**CITY OF ROCKVILLE PLANNING DIVISION
STAFF REPORT**

SUBJECT: Use Permit Application
USE2002-00647

Location: 22 West Jefferson Street

Building Height & Setback Requirements

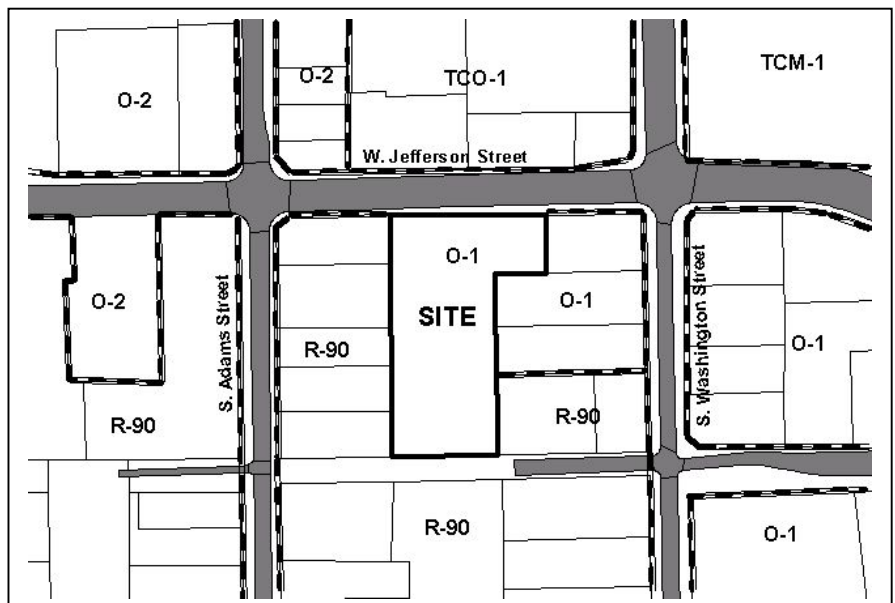
Building height is normally measured from the front street grade to the mid-point of a gable roof. In this case, where the proposed redevelopment is adjacent to residential uses, the building height must conform to the 30 degree slope line, which is measured from the common lot line. In this case, the existing office building is set back from the side property line 41 feet. The building height is 32 feet, so the existing building exceeds the minimum existing O-1 Zone requirements for the side yard setback vs. height. The proposed new addition on the east end of the existing building adjoins development in the O-1 Zone, so there are no additional height restrictions on that side. There are no setback requirements from the street in the O-1 Zone.

The proposed rear addition is 3½ stories high, measured from the existing ground level in the rear yard. The wall facing the adjoining residential lots is set back 66 feet from the property line. Staff measured the height based on an elevation of 435 feet at the rear of the lot at 108 South Adams Street. Staff has determined that the 30 degree slope line intersects the roof of the addition at the mid-point of its gable roof, therefore complying with the Code's new setback requirements. The rear building addition is set back 19 feet from the east property line, meeting the 15 foot minimum for walls with windows. It is set back 108 feet from the rear property line.

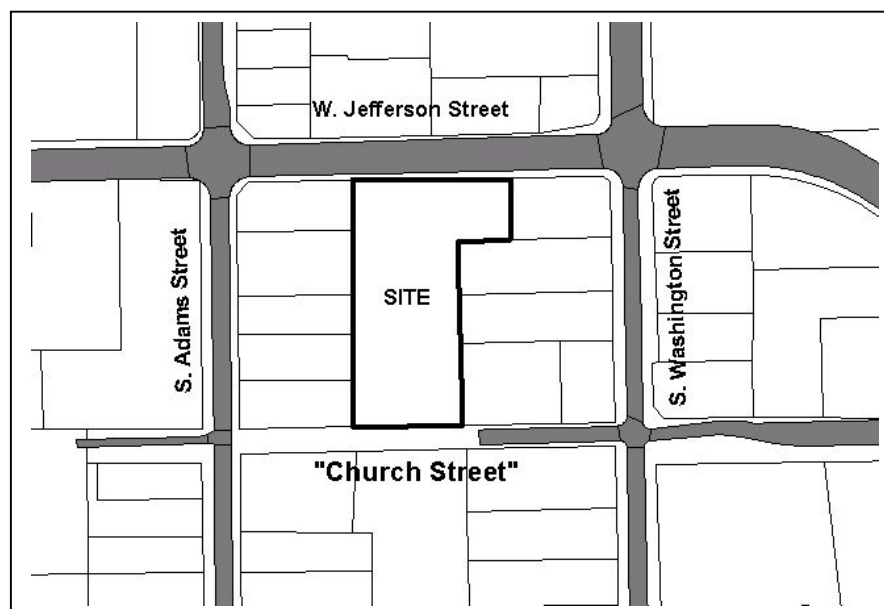
The proposed plan indicates the single entry drive, which is the location of the current entry drive from West Jefferson Street, to be 25 feet wide. However, this places the edge of pavement at 9.2 feet from the west property line instead of the 12 feet required. As noted above, the Planning Commission may allow up to a 20 percent adjustment in any of these requirements. A 20 percent reduction from 12 feet is 9.6 feet. This means that the proposed driveway would have to be moved to the east 5 inches to comply. There appears to be enough room to do this, perhaps without having to disturb the existing hedge planting between the existing driveway and the retaining wall that provides a light well for the lower level offices. Given the constraints of the location of the existing building, staff recommends allowing the 20 percent reduction for the entry driveway setback.

The proposed plan also shows a circle at the entrance to the garage and also to the new building addition. The edge of this circle is only 3 feet from the property line. Staff recommends that this area be redesigned so that the pavement is at least 9.6 feet from the property line, consistent with the driveway setback. The applicant has indicated that the dumpster will be removed from the plan and instead the applicant will use roll-out bins that will be stored within the parking garage.

2. The applicant is bound by all statements submitted on the site plan and use permit application.
3. Maintain 25 feet for a two lane driveway into the site. There will be full access into the site and right turns only out of the site. It will be allowed to be within 9.6 feet of the west property line.

4. All new maneuvering areas must be a minimum of 9.6 feet from the west property line.
5. The trash and recycling container location must be shown on the garage plan.

SOUTH SIDE ELEVATION
SCALE 1/8"

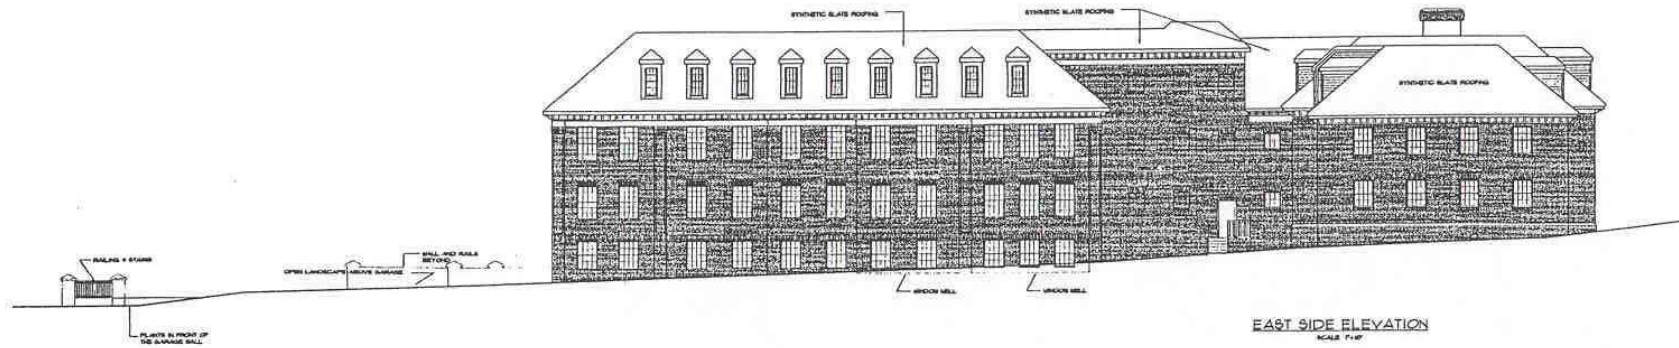
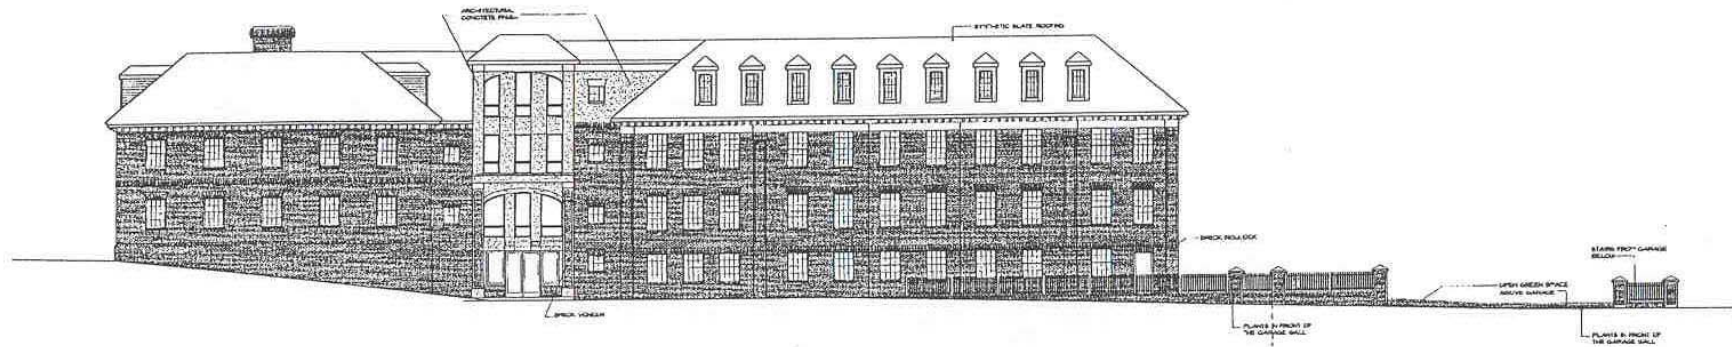
The Code now requires a building façade of 100 feet or more adjoining residential development to be articulated with 2-foot minimum off-sets. The proposed rear addition is 104 feet long. The proposed plan does indicate wall articulation to comply with this requirement.

There was concern over the continuous roofline and the placement of the pilasters, windows and dormers. They felt some of the wall breaks were arbitrary, and preferred a more cohesive design. The windows and dormers should line up. The overall design should reflect the Georgian Revival style of the existing building. The HDC wanted to

see a sample of the synthetic slate roofing material proposed for the building. The draft minutes of the meeting are attached to this report.

Staff recommends as a condition of approval of the Use Permit that the HDC review and approve the proposed addition to the building that is within the historic district prior to issuance of building permits.

22. Obtain final approval of the design of the new east wing from the Historic District Commission prior to issuance of building permits.
23. All the internal and external traffic control devices (i.e., signs, signals, markings, and devices placed on, over or adjacent to a roadway or pathway to regulate, warn, or guide pedestrians and/or vehicular traffic) must comply with the latest edition of the Manual on Uniform Traffic Control Devices (MUTCD); which is currently the Millennium Edition. A signing and pavement-marking plan must be submitted to the Department of Public Works and approved by the Chief of Traffic and Transportation before the issuance of a Public Works Permit.
